TECHNICAL SERVICE BULLETIN

Soft Top Wear Above B-Pillar

22-2274

Ford 2021-2022 Bronco

Figure 1

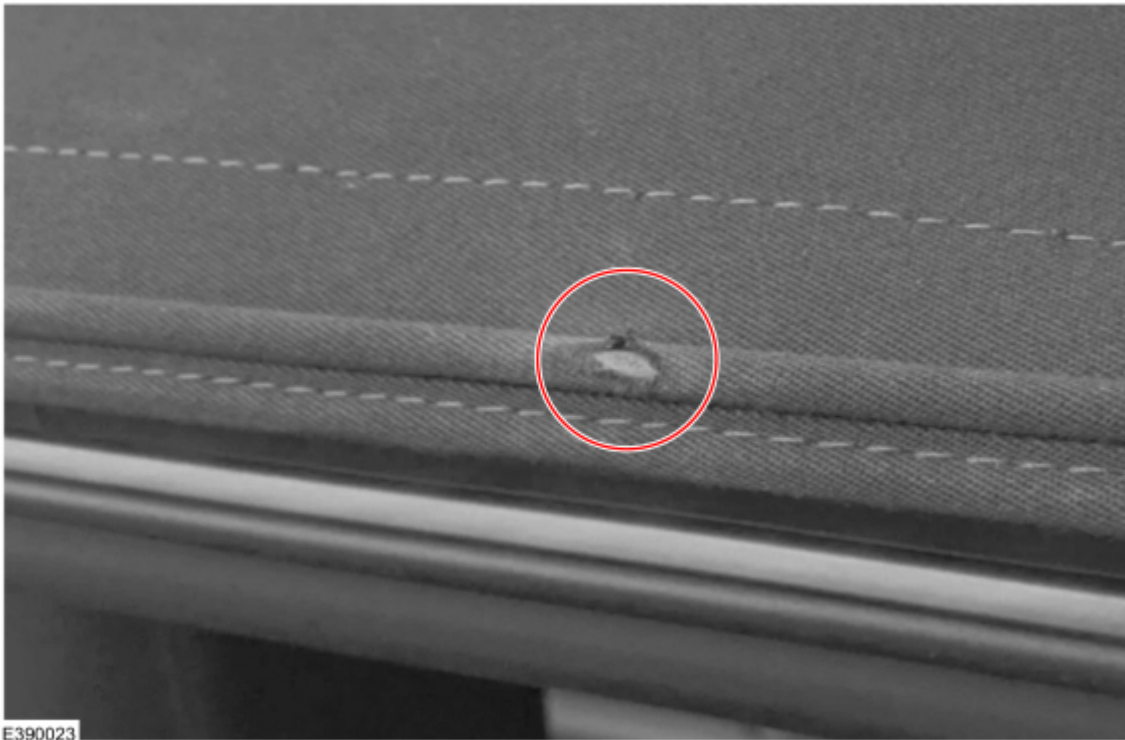
1. Does the soft top exhibit wear above the B-pillar similar to Figure 1?

(1). Yes - proceed to Step 2. Updated deflectors will be installed on both sides of the soft top frame assembly to prevent wear.

Figure 3

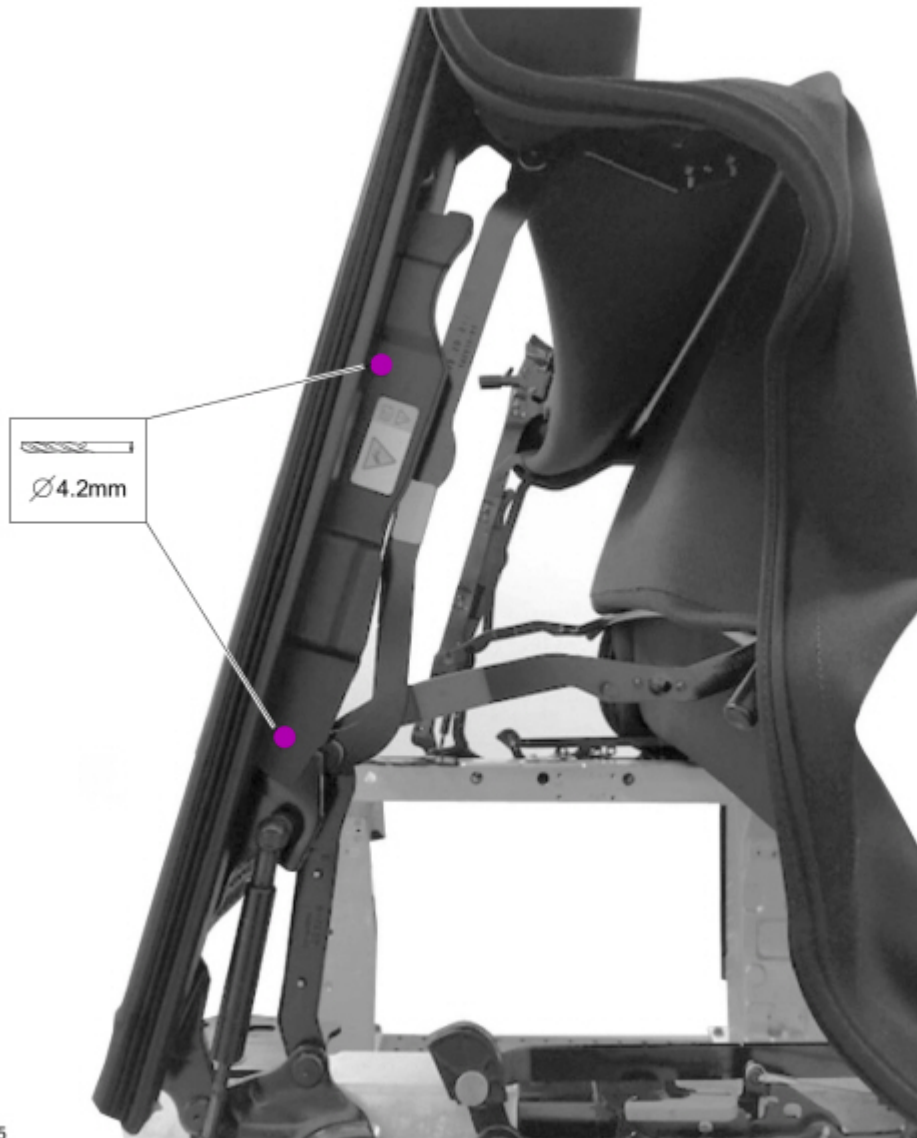
4. Locate each deflector on the right and left side of the frame assembly and drill out 2 rivets per deflector using a 4.2 mm (11/64 in) drill bit. (Figure 3)

5. Attach an updated deflector on each side of the frame using rivets, securing the new deflector to the frame assembly starting from the front moving to the rear.
6. Remove and replace the soft top cover. Refer to the Workshop Manual (WSM) Section 501-18A Soft Top > Removal and Installation > Soft Top Material.
